March 24, 2014

NOTICE OF ADDENDUM
ADDENDUM NO. 1
CONTRACT NO. 7206

STATE STREET RECONSTRUCTION
ASSESSMENT DISTRICT 2014

2
S-26
PLANTER SEAT WALL WITH PRECAST CAP
1"=1'-0"

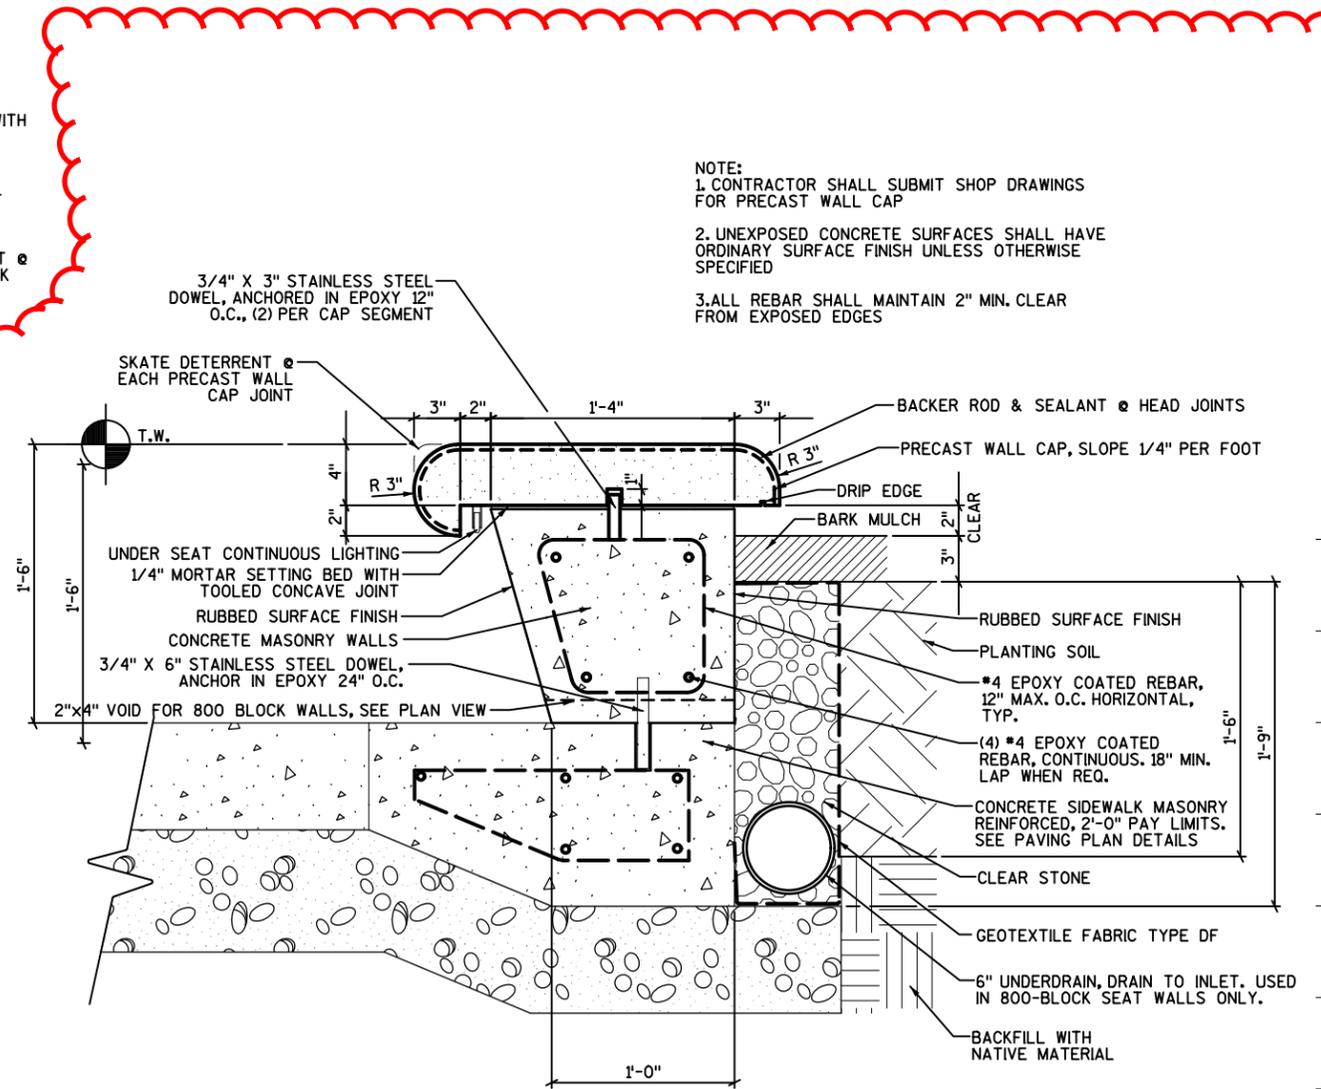
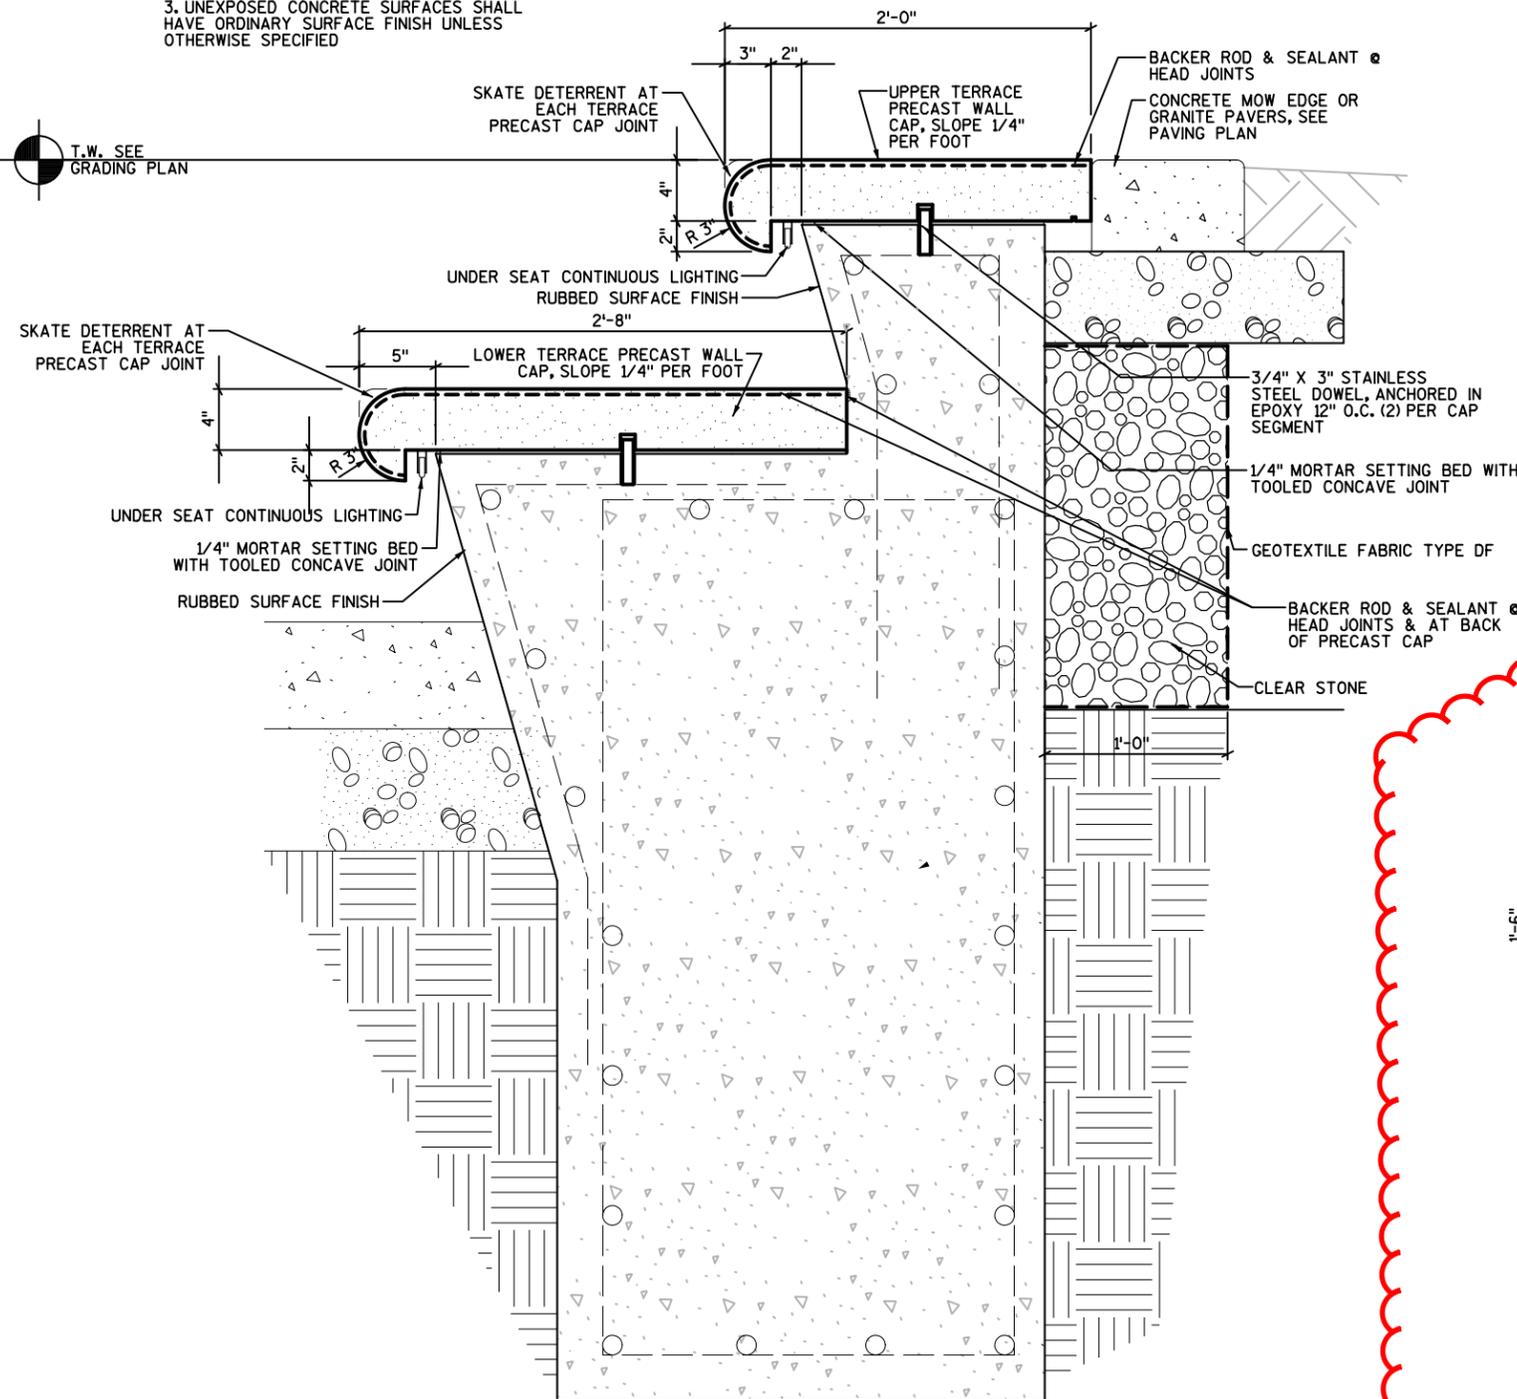
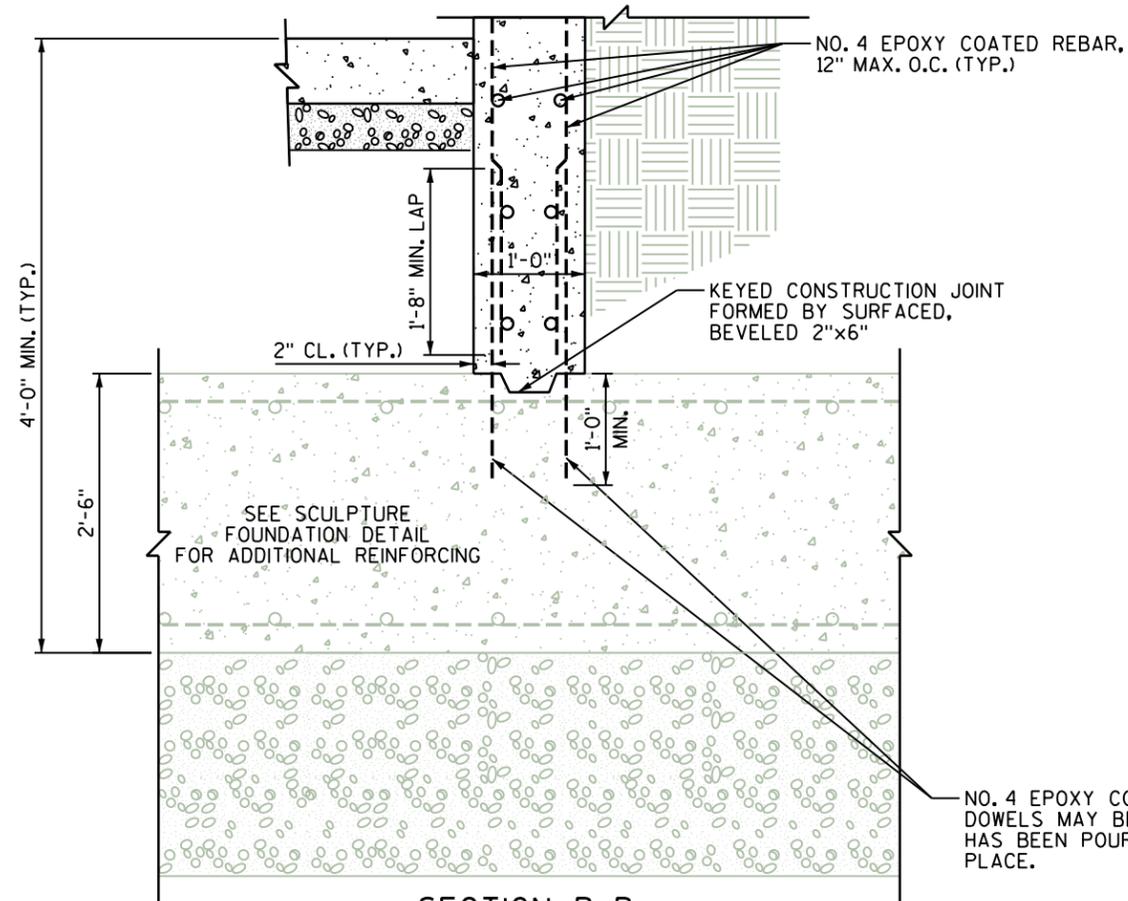
Replace Sheet S26 (Revised 3/21/14) – Added detail for Seat Wall with Precast Cap in planter condition.

REVISED 3/21/14: Added detail for Planter Seat Walls for planter areas in the 700 Block.

1 CAST-IN-PLACE CONCRETE WALL AROUND LEAF SCULPTURE FOUNDATION DETAIL
S45 SCALE: NONE

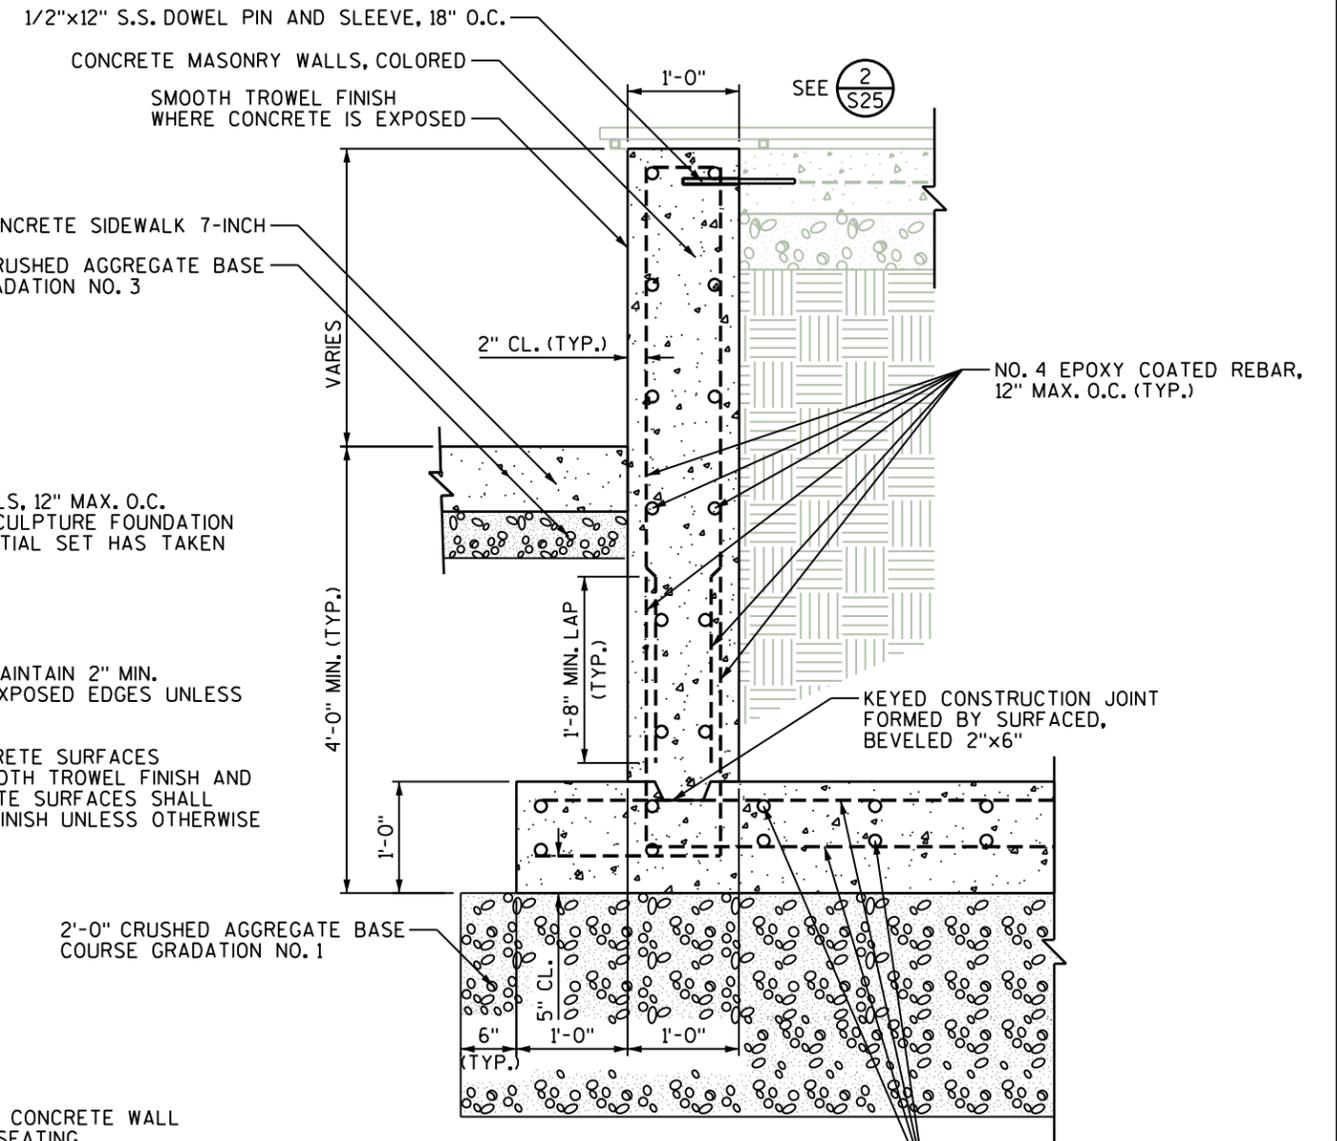
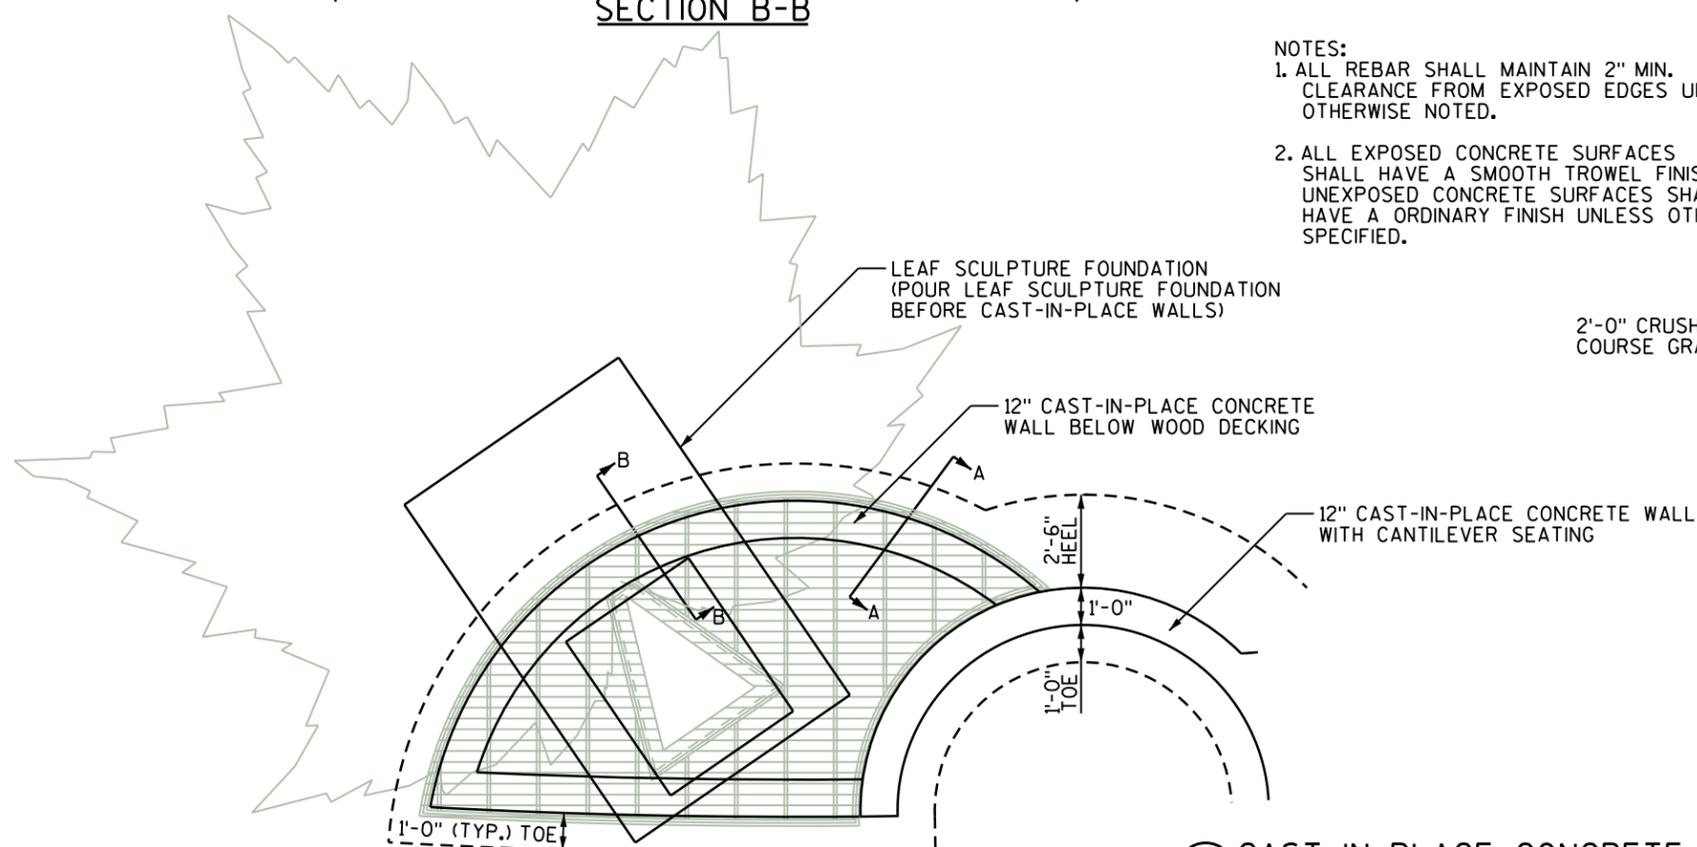
Insert Sheet S45 (New 3/19/14) – Details for Cast-In-Place Concrete Wall construction surrounding LEAF foundation

1 PL1 PLANTING PLAN - BASCOM HILL/ PARK STREET
1"=20' @ 11X17

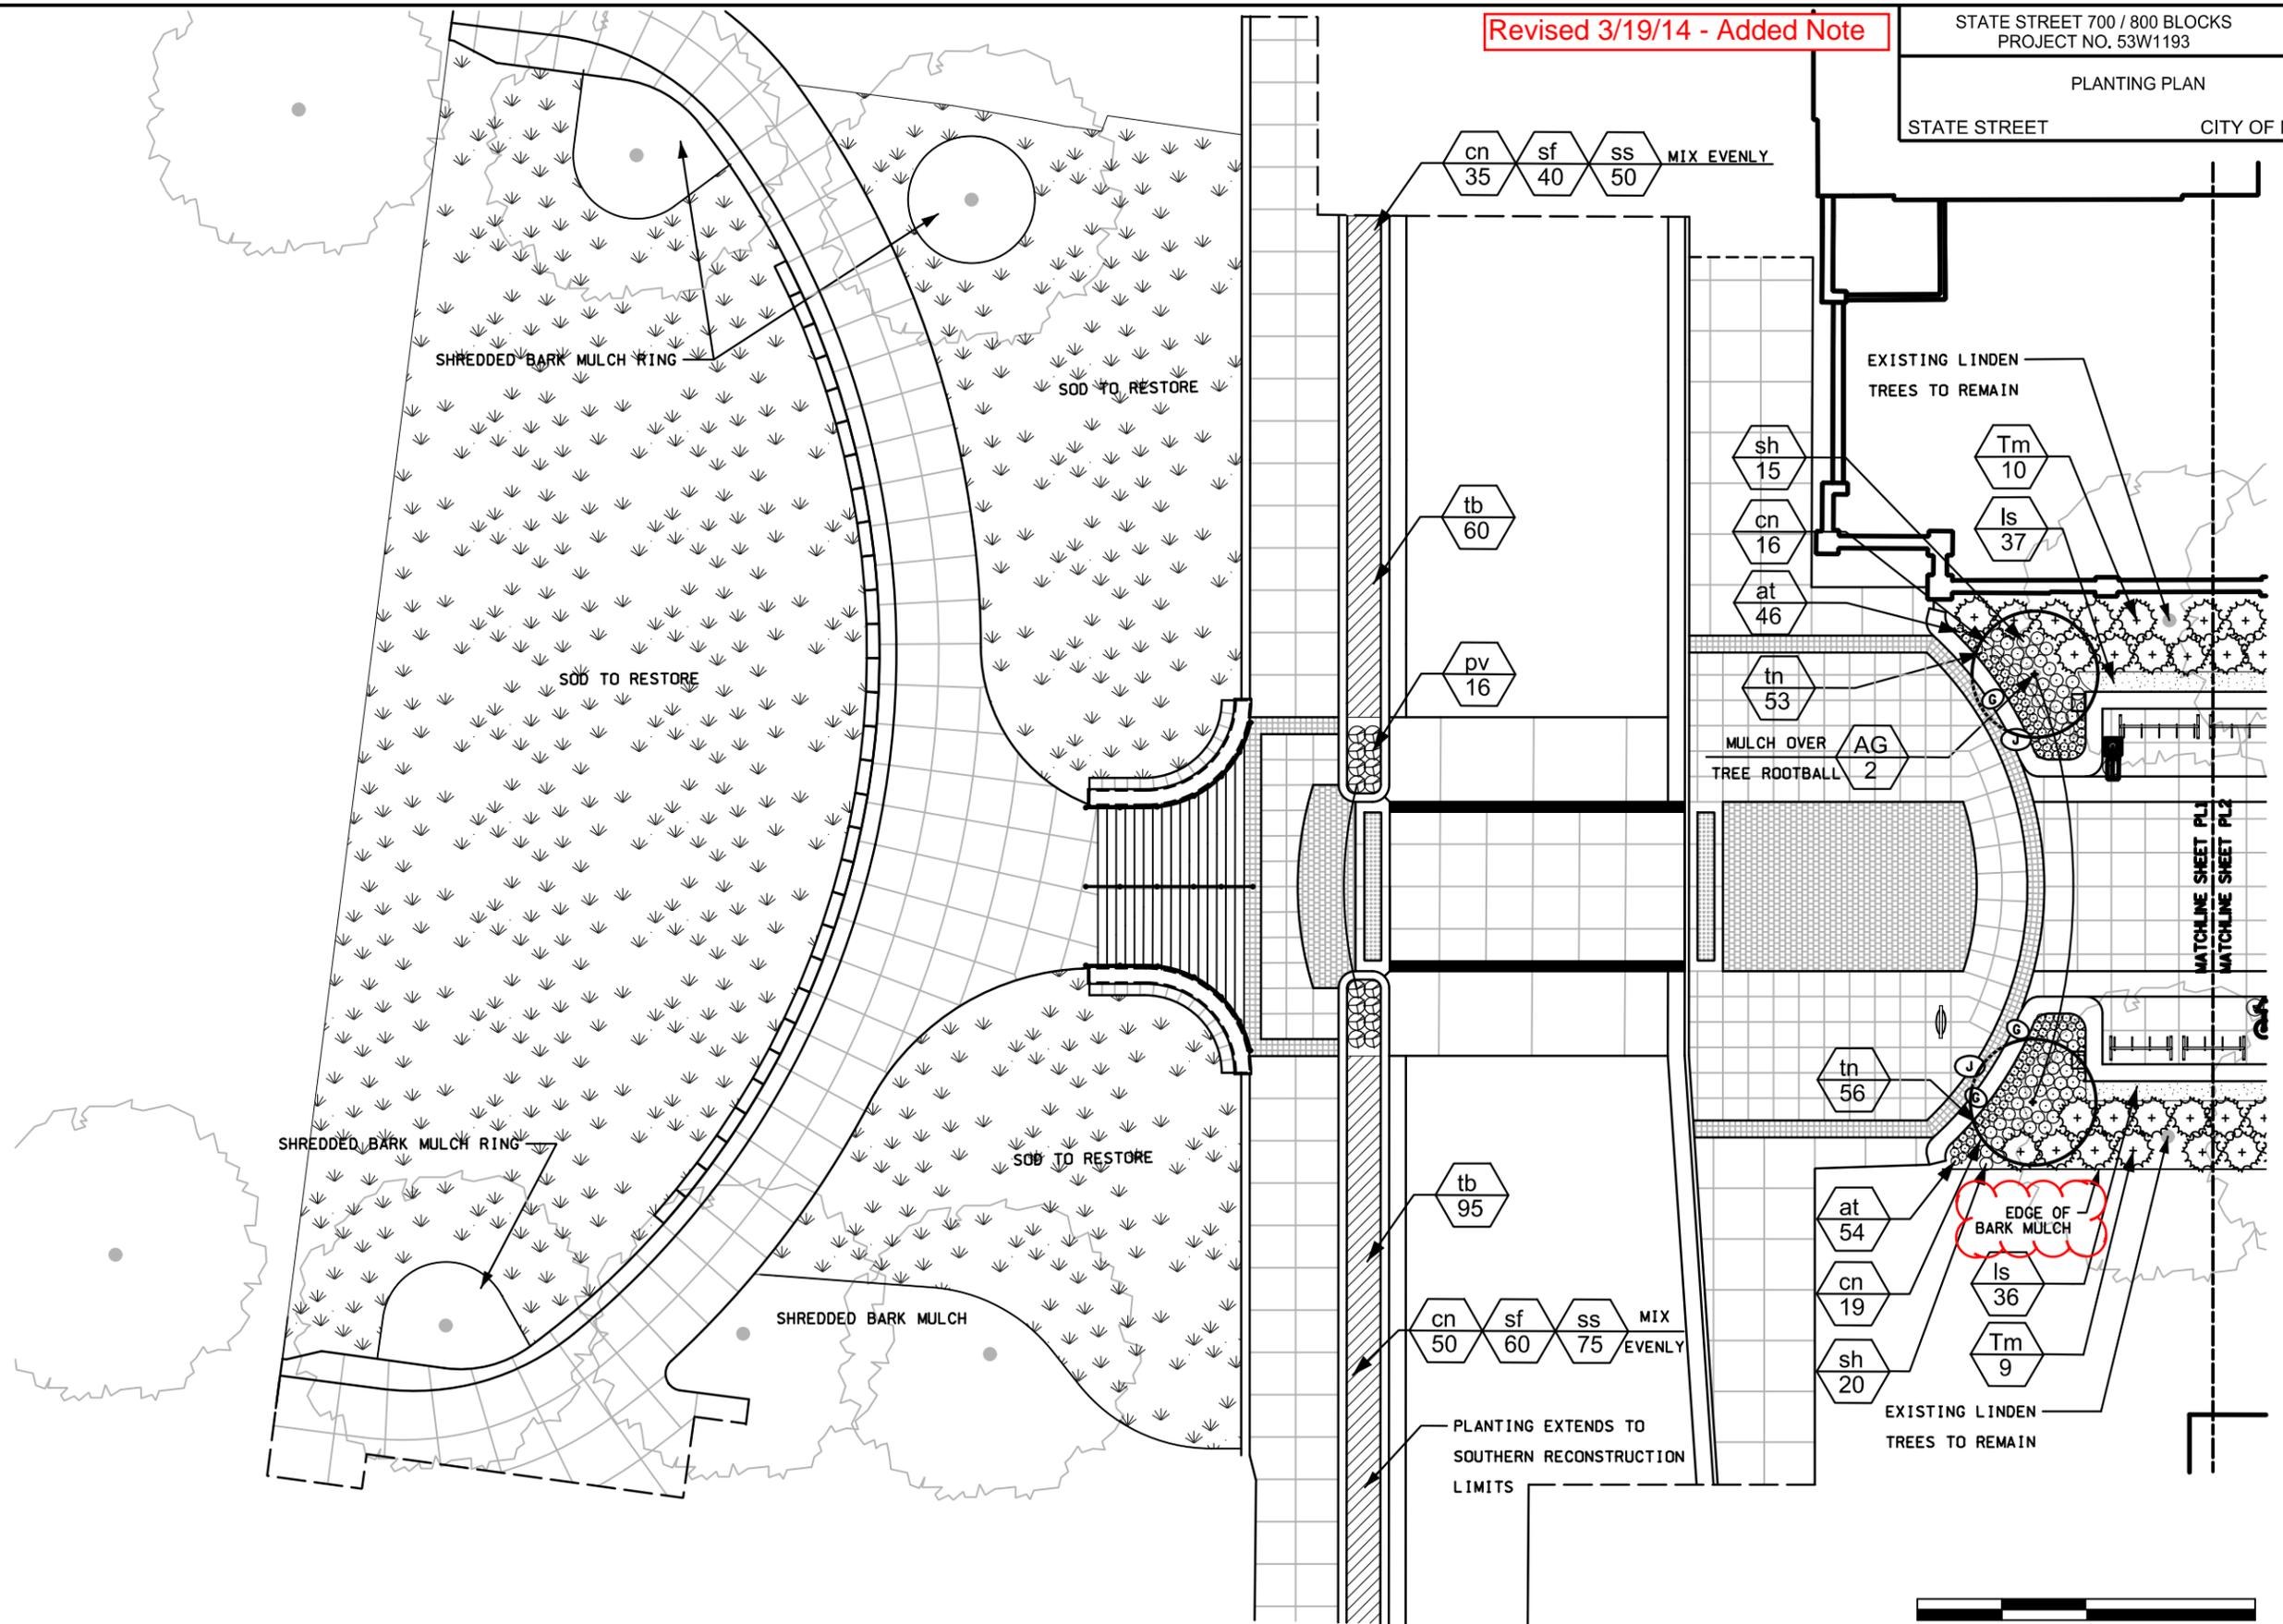
Replace Sheet PL1 (Revised 3/19/14) – Added limits for Bark Mulch item.

Revised 3/19/14 - Added Note
